Appl. No. 10/774,326
Amdt. Dated October 6, 2006
Reply to Office Action of July 12, 2006

Attorney Docket No. 81846.0035
Customer No. 26021

REMARKS

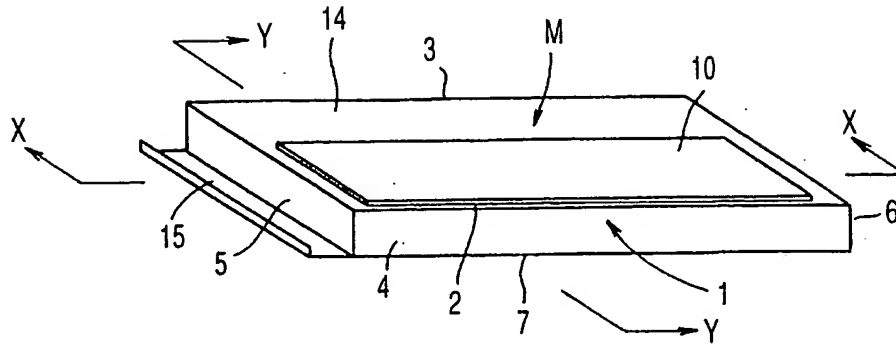
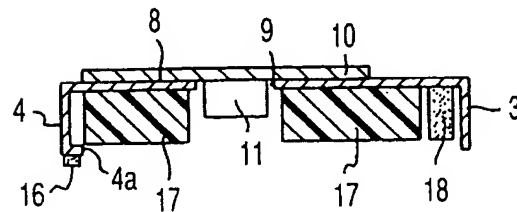
In contrast, the present invention requires that a lower surface of the solar cell is positioned above and is mounted to the uppermost surface of the base member. As shown in FIGS. 1-3, the present invention discloses that solar cell 10 is positioned above and is mounted to the uppermost surface of base member 1. This allows solar cell 10 to be easily mounted to base member 1. Yoshitaka does not disclose this feature. The present invention does not disclose or suggest that solar

cell 10 is positioned and mounted within a recess formed below the uppermost surface of base member 1.

FIG. 2

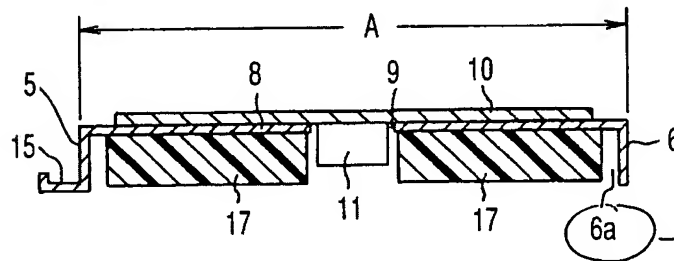
The attached sheet of drawings includes changes to FIG. 2 to delete reference sign 6a, replacing the original FIG. 2 sheet.

On page 2 of the Action, the drawings were objected to under 37 CFR 1.84(p)(5). In response, FIG. 2 has been amended to address the above objection. Reconsideration and withdrawal of the objection are respectfully requested.
